## RFI question and design team response

**GAMEDAY**  
190 Creekside Crossing,  
New Braunfels, 78130 Texas

# OFFICE DESIGN

**LIFE SAFETY PLAN & SHEET NO.**  
A1.00

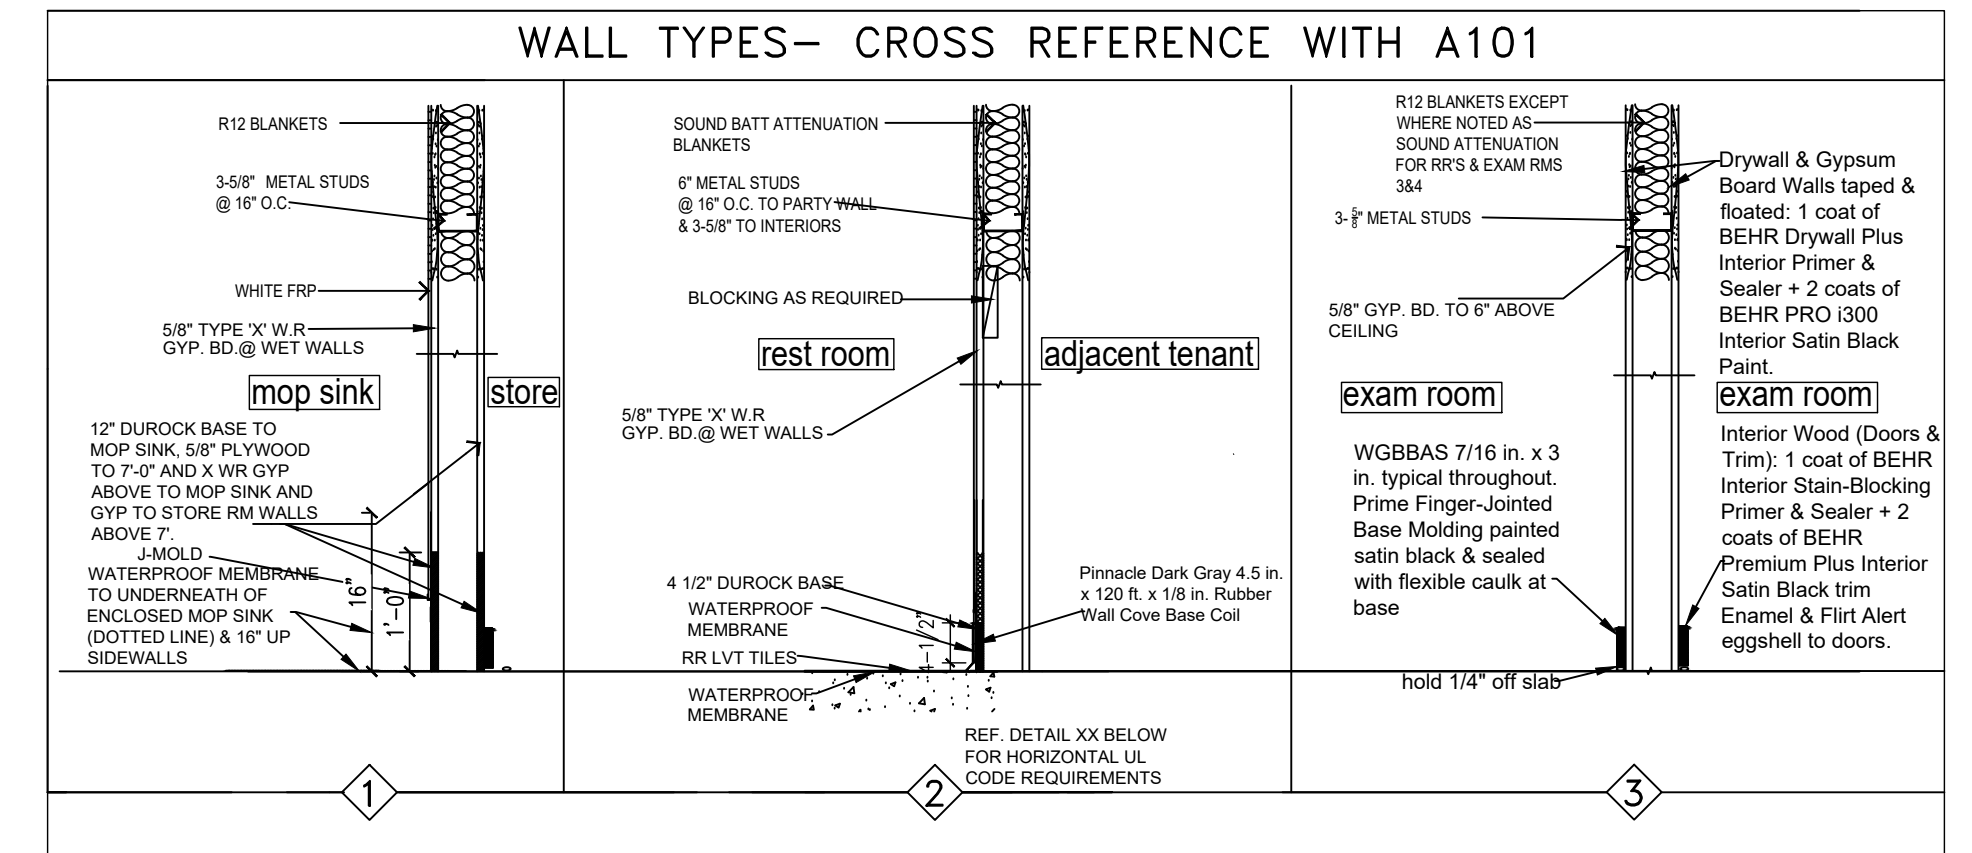
A1.01 on the southeast exterior wall – wall type is indicated to be type 5. This is detailed on A1.00 to be painted plywood? [See attached A1.0 Rev-1](#)

I understand the demising wall is to be to the roof deck, but what is the height of all the interior walls? [See Attached A1.0 Rev 1](#)

Is insulation to be included in all interior walls? [See Attached A1.0 Rev 1](#)

DATE	DESCRIPTION	BY
06.11.26	Demising wall to deck. All other walls to min. 9' above ceiling. R12 to all walls sound attenuation & 2" furring wall. Ceiling insulation throughout except over reception lounge.
